Attachment 1 Taharoa Ironsands Limited's response to the Panel's RFI

Appendix 1. Taharoa Ironsands Ltd Request for Information

Substantive Application

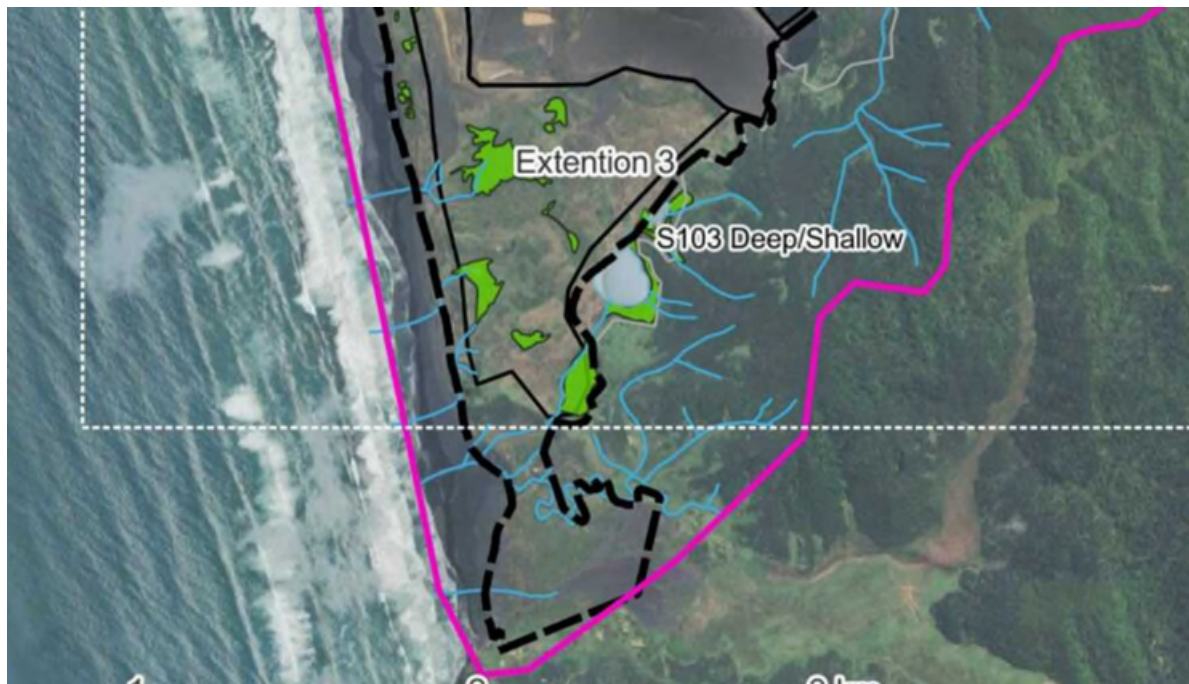
Is that understanding correct and if so **what plan or other reference within the application materials confirms this** as Figure 4.4 of the substantive application and Figure 1 of Appendix N (Hydrogeology) shows extension 3 of the Southern Block mining most of the site?

That understanding is correct. The area in the extreme south of the Taharoa C Block south of the escarpment is not proposed to be mined and this is accurately shown in both Figure 5 of Appendix O to the Substantive Application and in Figure 1 of Appendix N of the Substantive Application. For example, Figure 1 of Appendix N shows the extent of “Extension 3” area stopping short of the escarpment which aligns with the extent of “EXT 3” area shown in Figure 5 of Appendix O – I have enlarged and annotated the relevant part of Figure 1 from Appendix N below to assist:

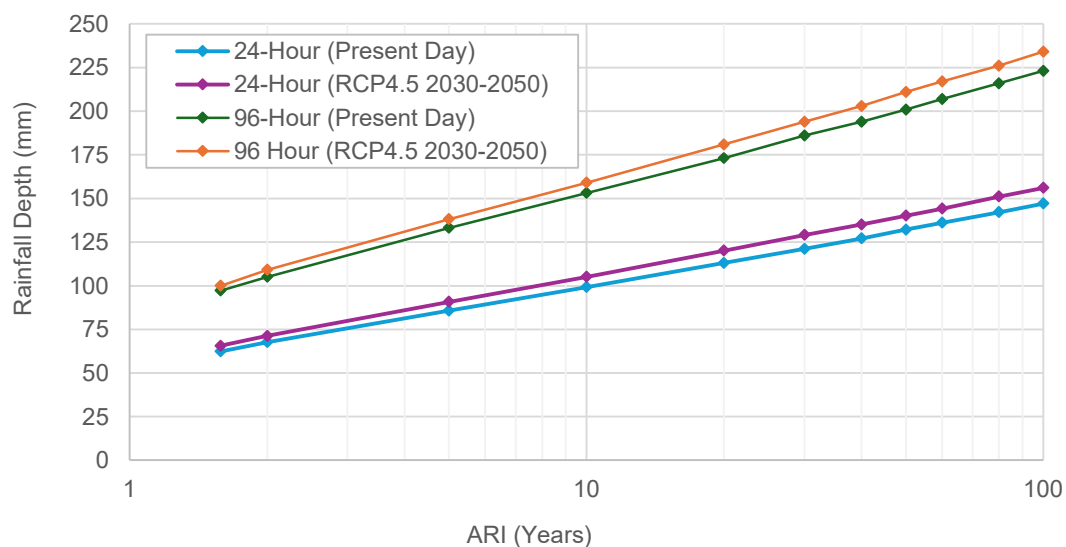
Section 6.2 notes that a section of Taharoa Road that is of concern regarding flooding during high lake levels is located along a topographic low (~10.5 m RL) and is close to current normal lake water levels. Figure 5 of Appendix I indicates around six occasions in the last eight years when Taharoa Road would have flooded. Given the legal baseline for the existing environment is the dam not being present (Appendix CC, paragraph 17(c)), **how does increasing the lake level by 2.5 metres not increase the risk of flooding at the road?**

The Panel has identified the difference between long-term average rainfall, and extreme rainfall intensity. We stated that annual and seasonal changes in average rainfall due to climate change will be fairly neutral (over the duration of consent sought). However, whilst not stated we agree that infrequent, large storm events are projected to become more intense.

The frequency and number of high lake level events and inundation of the road is not anticipated to materially change due to climate change over the duration of consent sought. To provide high-level context to the specific question of how many additional flood events may be anticipated for the road, we have compared Earth Science NZ's (formerly NIWA) High Intensity Rainfall Design System (HIRDS) data for the current day and RCP4.5 scenario design storm rainfall, with the following analysis assumptions:

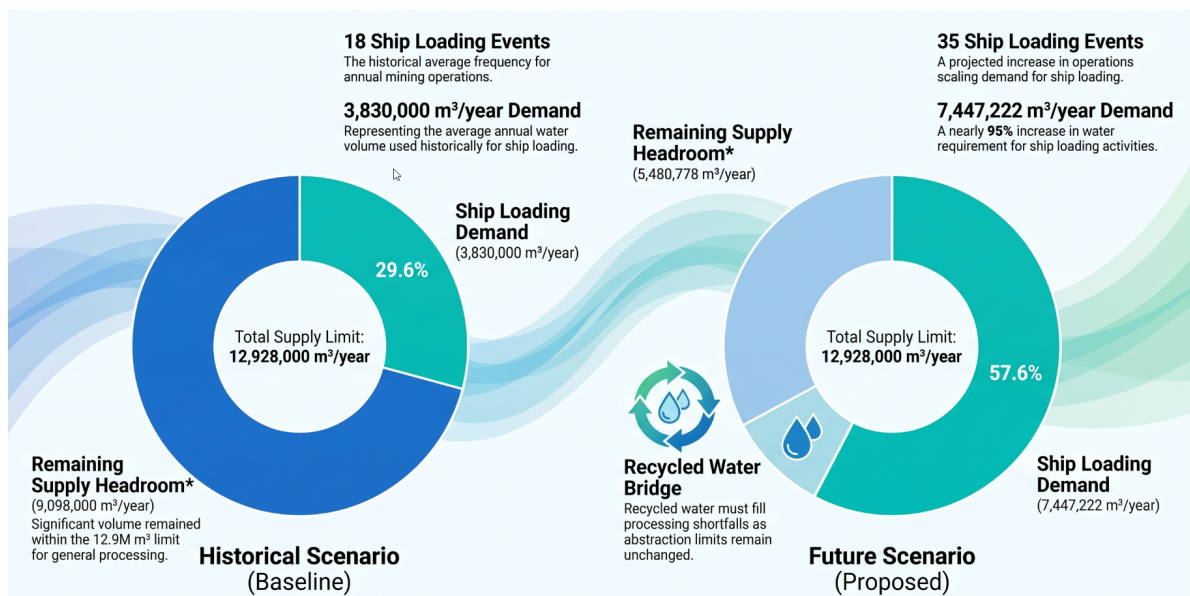
Are there any implications for the water balance model of using recycled processing water and discharging that to the CMA through the ship loading process, particularly during summer periods when water abstraction rates are greater than summer natural catchment inflows (see bottom of page 23 of Appendix I), and given the planned increase in number of ship loadings proposed?

Abstraction Scenario S3 (maximum future water takes) represented the maximum abstraction volumes sought under the application. It is assumed that shortfalls will be made up from recycled water and this is expected to increase as mine progresses from dry to wet mining. Conversely, if TIL were to use even greater volumes of recycled water from the mining operation, this would result in less abstraction from the lake, and summer drawdown of the lake would likely be lower.

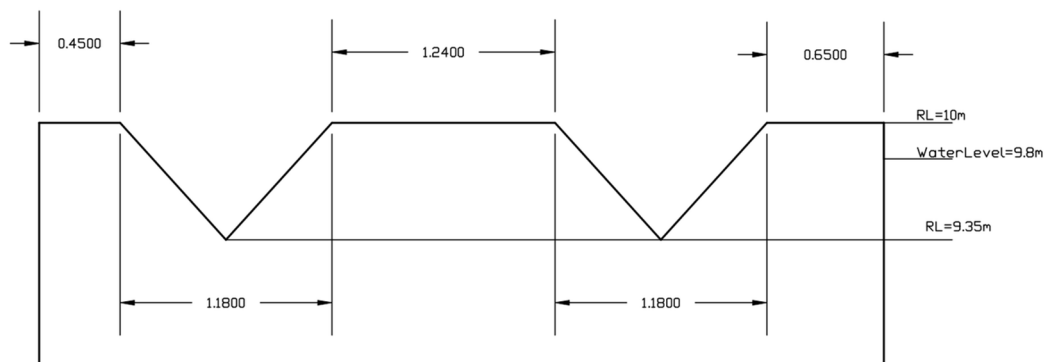
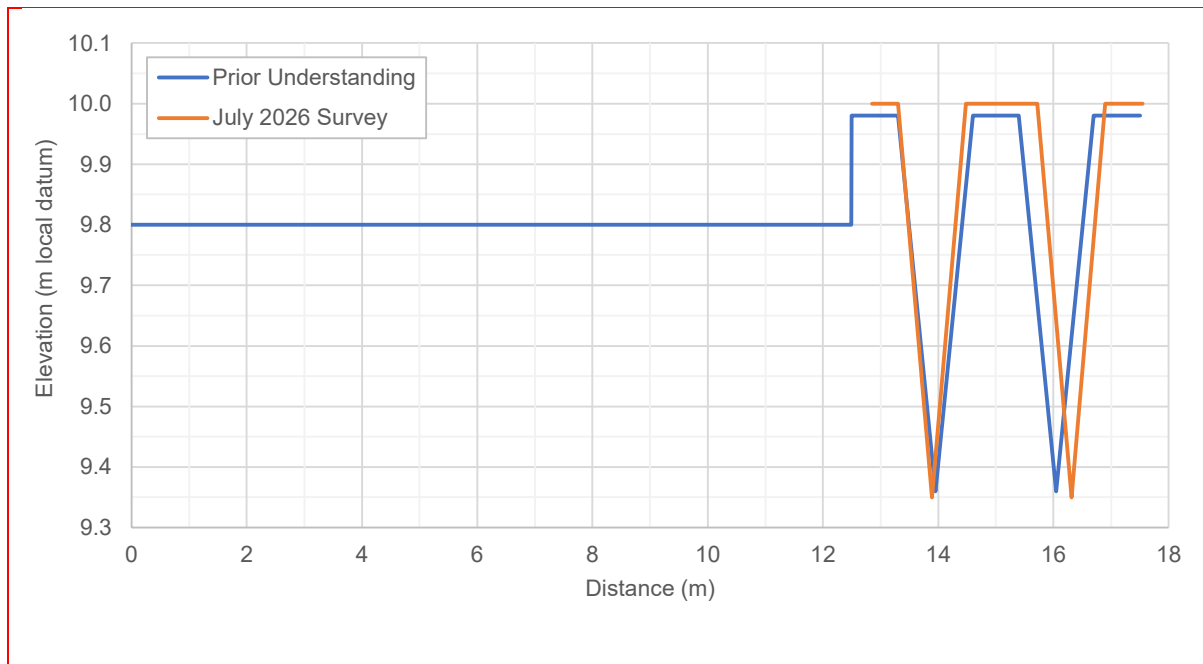
“As seen in Figure 6 the lowest water level measured behind the dam structure was 9.45 m RL in early 2014. This is equivalent to 0.09 m head above the invert of the two v-notches in the weir structure (Figure 12). Applying a standard weir flow calculation, the flow through the outlet weir at this level would have been 10 L/s.”

In response to this question from the Panel, TIL resurveyed the weir, and were successful in obtaining accurate dimensions of the two v-notch components of the weir. The surveyed dimensions are illustrated in the schematic below.

This matches relatively closely to our prior understanding of dimensions, and is compared to the schematic used in our assessment (Figure 12 – Appendix I) below. Key differences of note are:

- The 2026 survey has a slightly lower invert at 9.35 m RL (compared with the prior value of 9.36).
- The 2026 survey has a shallower v-notch angle at 84.5 degrees (compared with the prior value of 92 degrees).
- The separation between the two v-notches is 0.44 m wider (note – this has no effect on flow through the two v-notches).

The flow through the two v-notch weir sections at water level of 9.45 m RL (at the weir) (equivalent to 0.1 m head above the invert) is 10 L/s. Hence there is no change to the minimum flow requirement through the weir. The slightly lower invert level from the July 2026 survey dimensions in combination with the shallower v-notch angle results in the same flow rate (rounded to the nearest 1 L/s) as previously determined.
